PROJECT: Pavement Maintenance at Various Sites

OWNER: Clovis Unified School District

BID NO: 2890

2022 PAVEMENT MAINTENANCE
 ADDENDUM 03

EXHIBIT A - ASPHALT PAVEMENT SECTION DETAIL

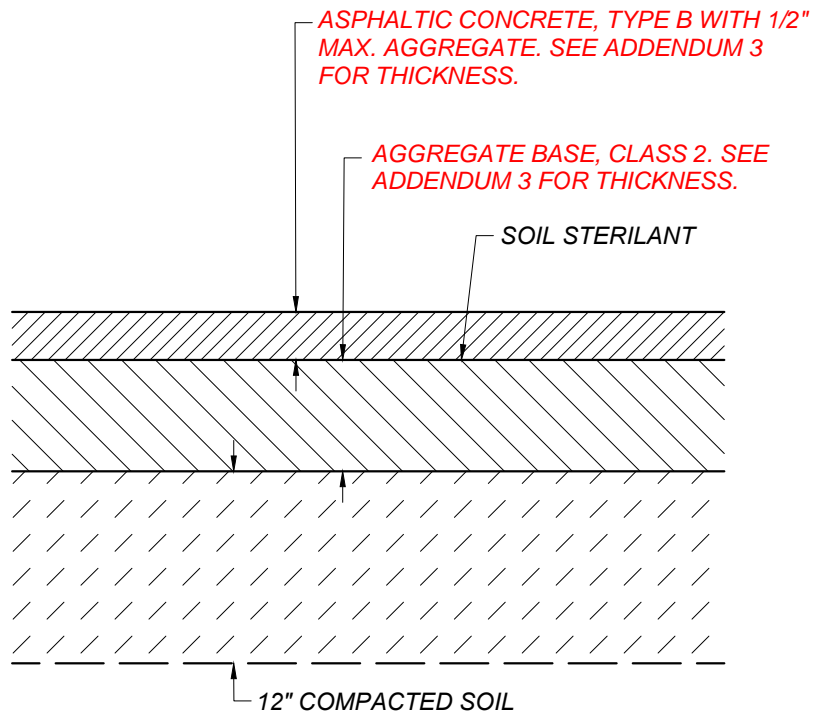
1. Revise the asphalt pavement structural section detail as shown in the attachment **EXHIBIT A – ASPHALT PAVEMENT SECTION DETAIL**. Assume the following pavement structural sections for the following sites:

- **Buchanan High School:** 3" AC over 10.5" Class 2 AB over 12" compacted subgrade
 - **Clovis High School Playcourts:** 2" AC over 4" Class 2 AB over 12" compacted subgrade

- **Clovis High Access Road:** 3" AC over 10.5" Class 2 AB over 12" compacted subgrade
 - **Clovis West High School:** 3" AC over 6" Class 2 AB over 12" compacted subgrade

- **Community Day School Parking Lot:** 3" AC over 4" Class 2 AB over 12" compacted subgrade
 - **Community Day Playcourt:** 2" AC over 4" Class 2 AB over 12" compacted subgrade

- **Professional Development Center:** 3" AC over 4" Class 2 AB over 12" compacted subgrade
 - **CART:** 3" AC over 4" Class 2 AB over 12" compacted subgrade

- **Jefferson Elementary:** 2" AC over 6" Class 2 AB over 12" compacted subgrade
 - **Mickey Cox Elementary:** 2" AC over 6" Class 2 AB over 12" compacted subgrade

- **Pinedale Elementary:** 3" AC over 4" Class 2 AB over 12" compacted subgrade
